Small-Scale Experiments: Effects of Chemical Reactions on Debris-Bed Head Loss

A Subtask of GSI-191

NUREG/CR-6868
LA-UR-03-6415

This report documents an initial study of chemical effects on sump performance in pressurized-water reactors (PWRs). This report was previously published as LANL Technical Report #LA-UR-03-6415, dated October 2003. It is now published as a NUREG/CR report to provide proper context of this study and better accessibility for stakeholders. The U.S. Nuclear Regulatory Commission (NRC) initiated this study in response to a concern raised by the NRC's Advisory Committee on Reactor Safeguards (ACRS) during its review of staff activities related to the resolution of Generic Safety Issue 191 (GSI-191), "Assessment of Debris Accumulation on PWR Sump Performance," in February 2003. Specifically, the Committee raised the concern that chemically induced corrosion products have the potential to impede the performance of emergency core cooling system (ECCS) recirculation after a loss-of-coolant accident (LOCA) at a PWR plant. To support this concern, the Committee cited such evidence as the gelatinous debris found in the post-LOCA sump pool at the Three Mile Island pl

Figure 2-1. Illustration of a LLOCA event occurring in a PWR plant.

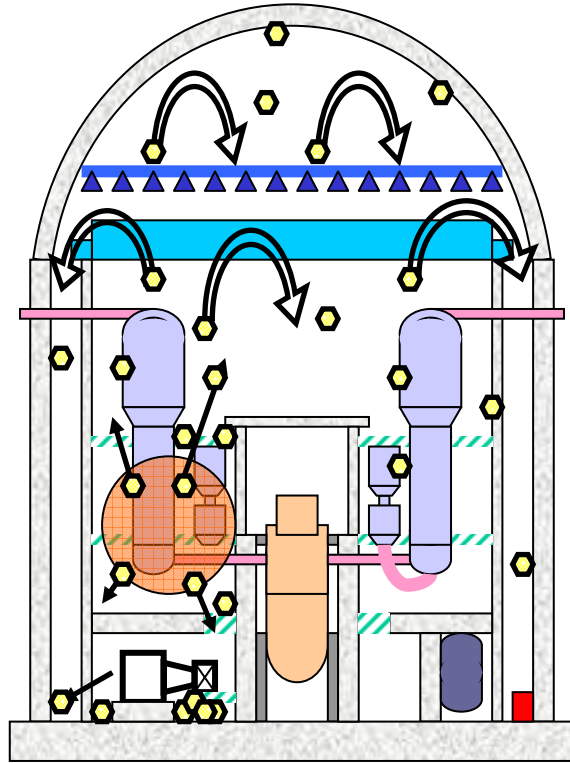
- 4) Improve or replace the time-line given on Figure 2-1. There is too much detail in the blowdown phase and not nearly enough in the later phases, where the processes important to screen blockage, take place. Perhaps the time-line format of Appendix C should be adopted. In any case, add more information. Put in the system temperature for each phase of the transient. Put in the water level and the pump and spray flow rates. A lot more detail in the period from 0.25 hours to 24 hours is needed.

Pg. 5, Figure 2-1. This figure is not adequately discussed. I would recommend that it be combined with Table 2-1 and Appendix C to provide a more comprehensive picture of the time/temperature/chemical environment that is the basis for your tests.

There is mention of “long-term headloss”. Need a brief discussion of what this means. It would be nice to tie the discussion into Figure 2-1, and put the time frame in the context of the LLOCA.

Again, Figure 2-1 needs to be expanded and integrated. It should be possible to integrate the information in the appendix either into the figure or into the discussion of the figure.

Figure 4-2. Schematic of small-scale test loop.

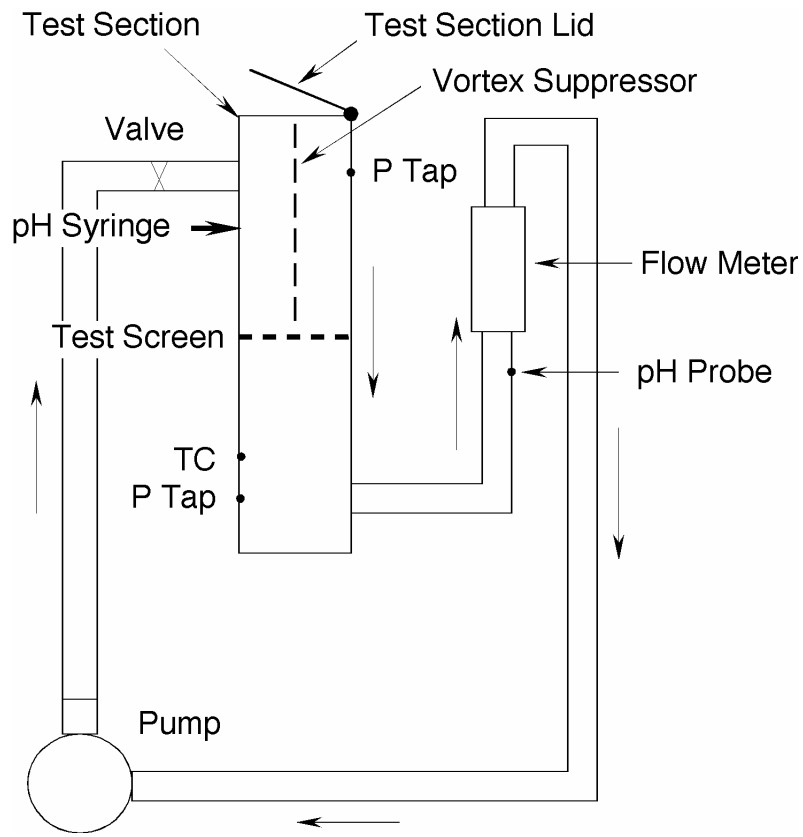
Section 4.3 – Include labeling of lid and vortex suppressor in Figure 4.2.

Figure 4-9. Head loss vs material concentration.

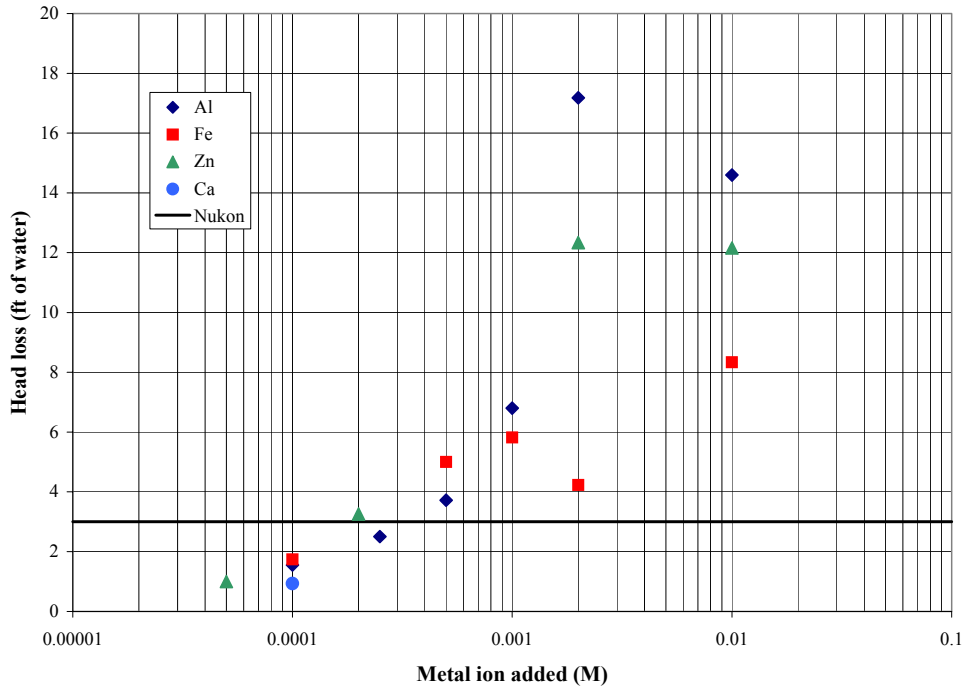
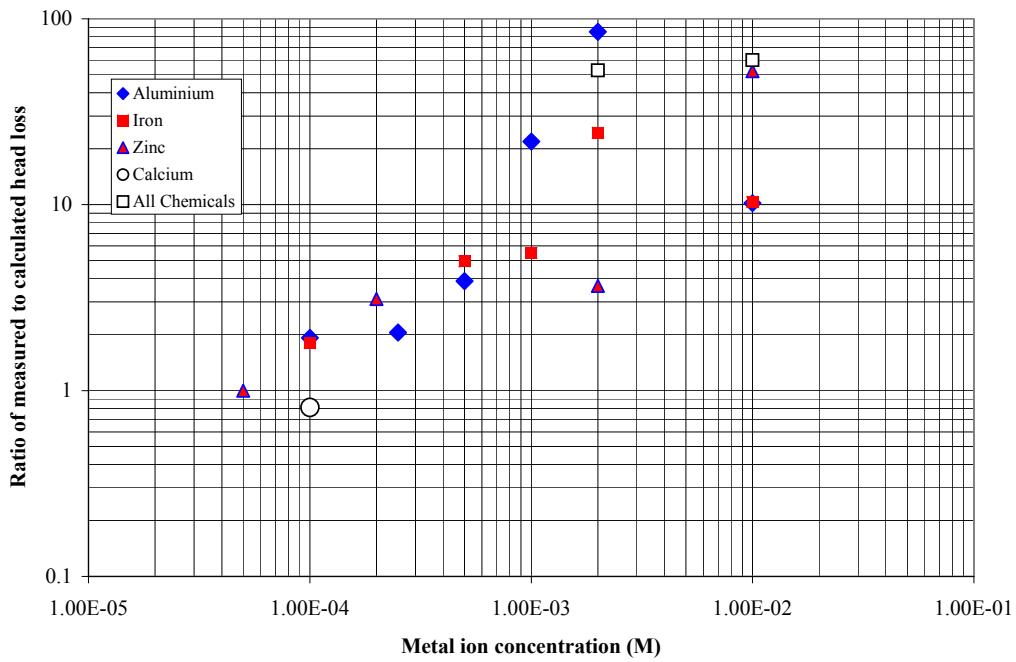
- a) Replace the variety of metals that are in the pool by an equivalent quantity of zinc. (I believe Figure 4-9 of the draft report can be used to justify what is selected.)

- 6) Reduce the head loss results of Figure 4-9 to a form of flow resistance which can easily be used by someone trying to evaluate the safety of a plant. As the results are presented now they are in a form peculiar to the apparatus used by you. I also suspect that most of your data is not in the range of pressure drops or mass velocities of interest to a user. I suspect that they are too high. Extrapolate right down to zero or a very low flow rate. Don't ask the user to extrapolate or reduce your data, do it for him.

Figures 4-9 and 4-10 – Include only the data from the experiments that met the test requirements of time and temperature. Provide a fitting curve for each type of data.

Figure 5-19. Zinc granules after exposure (oven at 80° C for 3 days) under optical microscope (magnification 49).

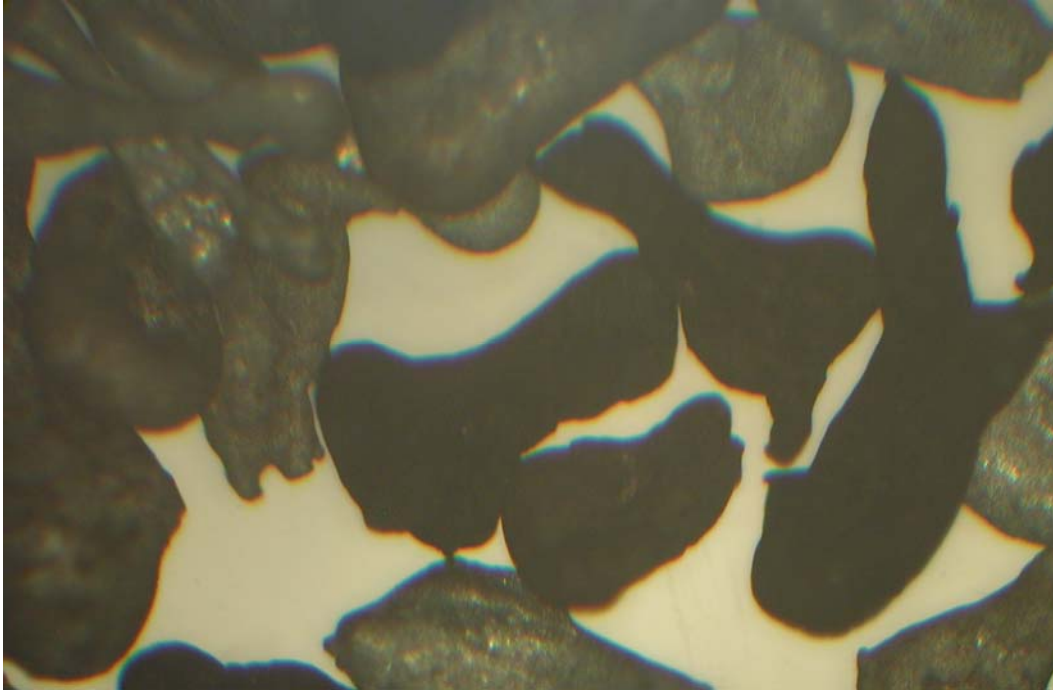
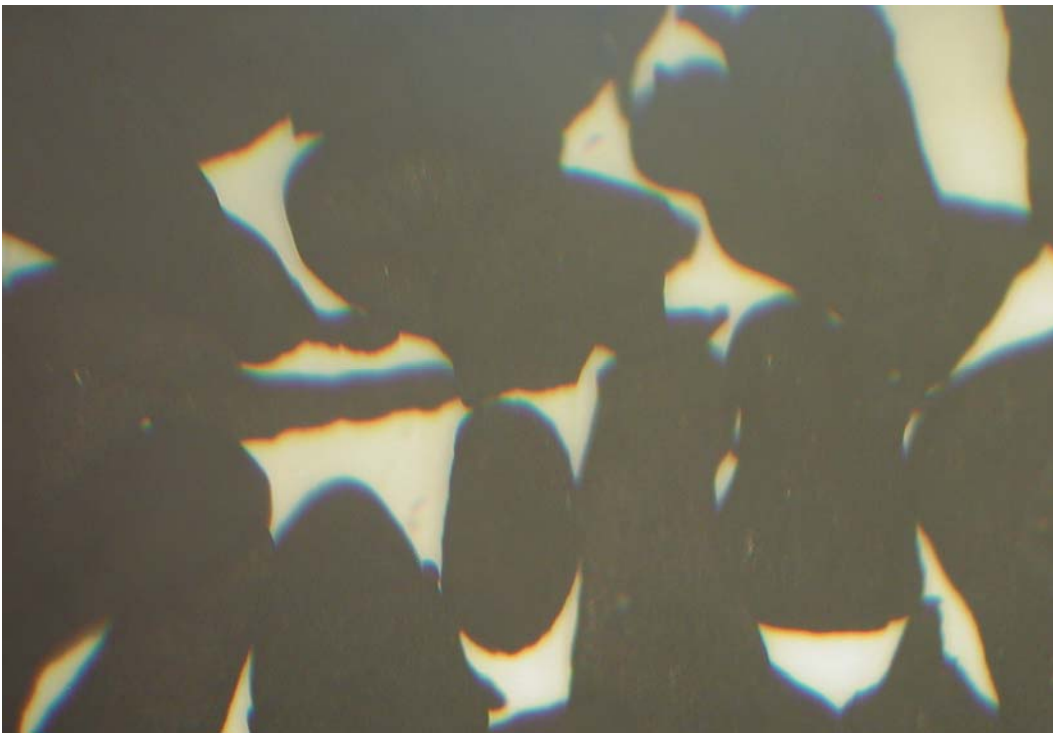
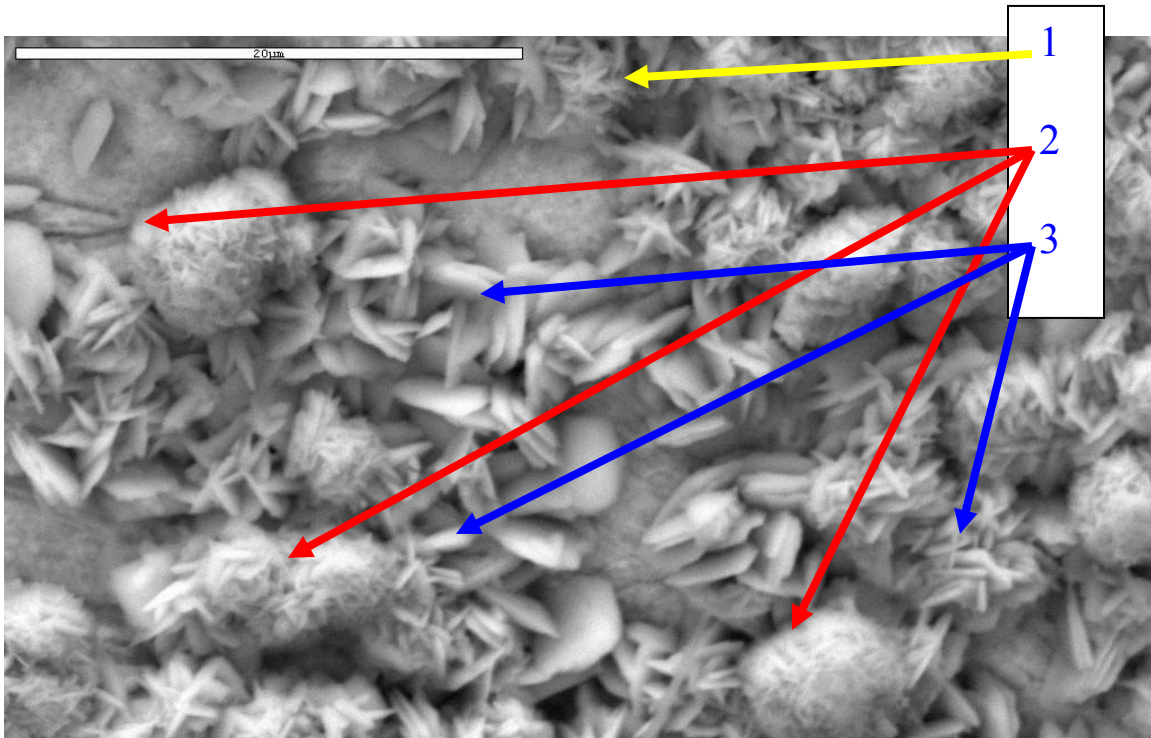
Figures 5-19 to 5-21 – What is your explanation of the differences in these figures?
